REPORT TO THE ECONOMIC DEVELOPMENT PLANNING COMMITTEE - PUBLIC MEETING – 3 DECEMBER 2013

2013-139-12

PROPOSED AMENDMENT TO ZONING BY-LAW 194-94

241 PARK STREET

SCHEDULE "A" TO REPORT 2013-139-12

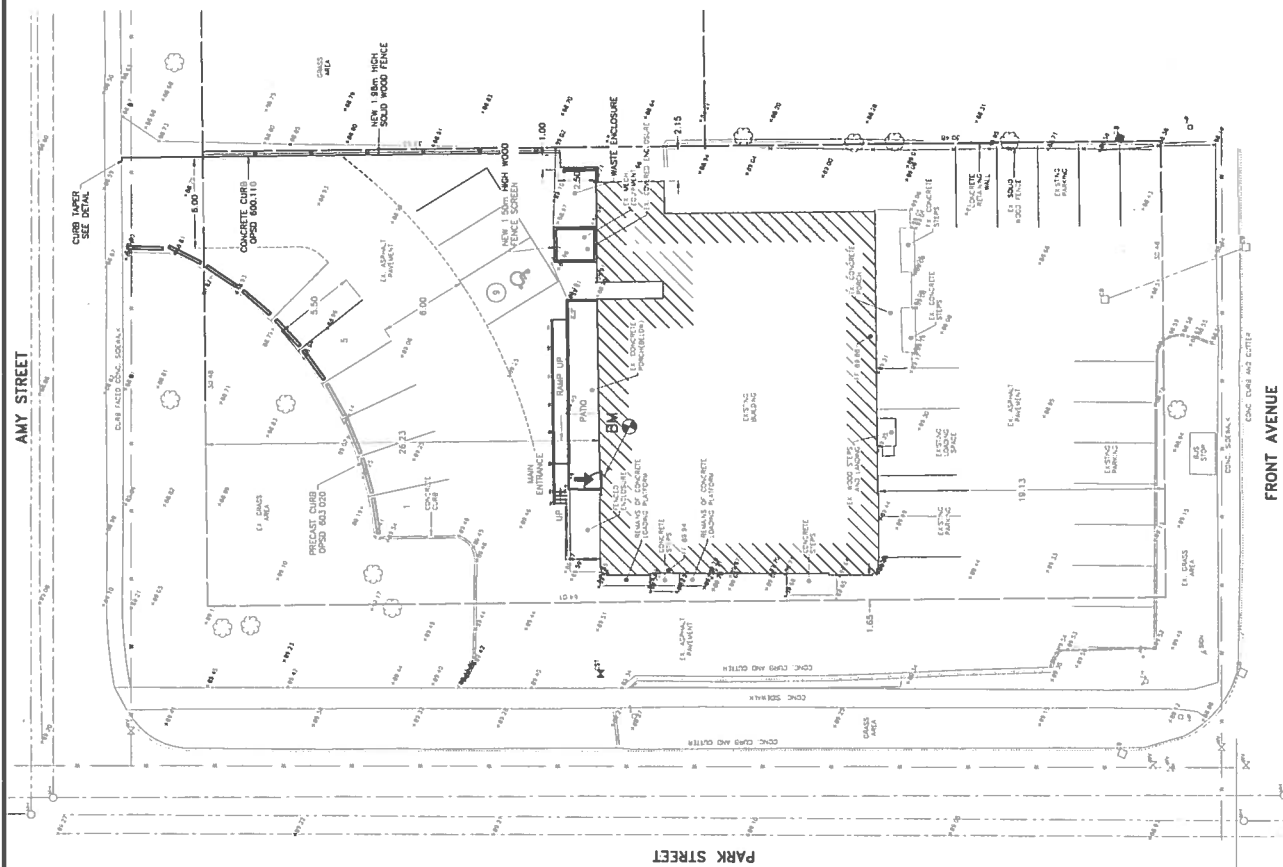
A site plan forms part of this site specific zoning and upon review of that site plan it appears a mistake has been made by the engineer designing the plan. As I was advised the drainage of the paved area was to result in deposit into the grass area within the property at the north west side. The elevations shown on the plan, which are existing, would direct all flow from the paved services to the east side of the property and result in depositing the run off precipitation on to the vacant lot to the east. A solid curb is proposed along the east side and space parking curbs along the north and west side of the pavement area. The design of the parking lot would result in all the run off precipitation flowing into Amy St and run easterly to the catch basins in front of 17 Amy St, 2 lots away. This area of Amy St is already flooded during the winter as the street is narrow and the plow pushes snow onto the sidewalks and the sidewalk plow pushes it back into the street and covers the catch basins. Drainage of the parking area should be retained within the property of 241 Park St.

The wood fence proposed along the east property line is a compromise to the existing zoning by-law by not requiring a buffer zone as was required in a earlier site plan agreement at this property. The buffer zone could be less of an issue if the wood fence was required to cover the full length of the east commercial property line as the plan shows an area at the south end by the proposed waste enclosure where there is no fence shown along the property line. The full commercial property line should be fenced.

The proposed waste enclosure is proposed to be only 1 meter from the property line. As the north side yard of the building is consumed by this proposal it would be a better location for the waste enclosure on the south side against the building on either side of the existing wooden landing which accesses the commercial operation associated to this application.
